REVIEW OF PLANS AND SPECIFICATIONS

PROJECT: Chapparrel Estates

WATER QUALITY DIVISION REFERENCE NUMBER: 77-351

ACTION: NOT AUTHORIZED FOR CONSTRUCTION. See comments.

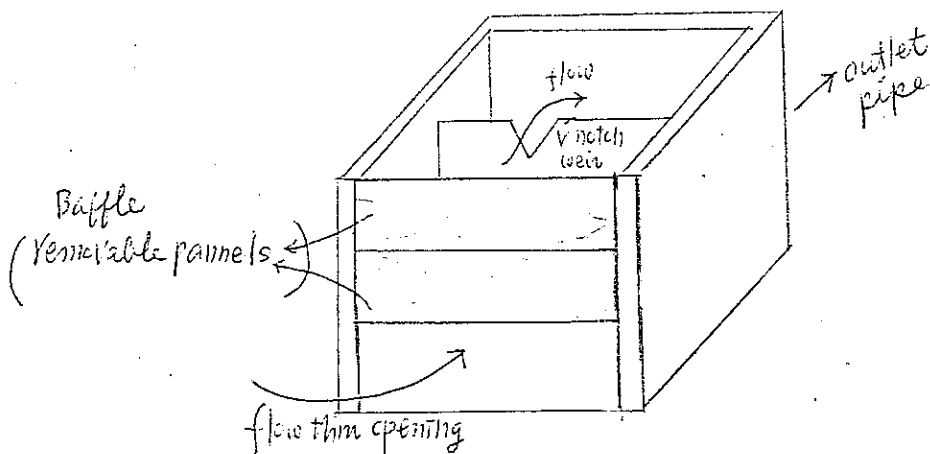
- 1). What is the design population in 1990? Your design note indicates that 1990 design flow is estimated 87 gpm, which is equivalent to 1253 people, assuming 100 gpd per capita as average flows. However, the total area of the primary cell is 10.06 acres, which is capable of handling sewage flow for only 1006 people based on the design criteria of 10 State Standards. Please clarify.
- 2). The V notch weir should be preceded by a baffle so that the baffle can prevent scum or floating material from accumulating around the weir area and minimize the effect of direct wind action on the weir. The design of outlet box shown below is strongly recommended.
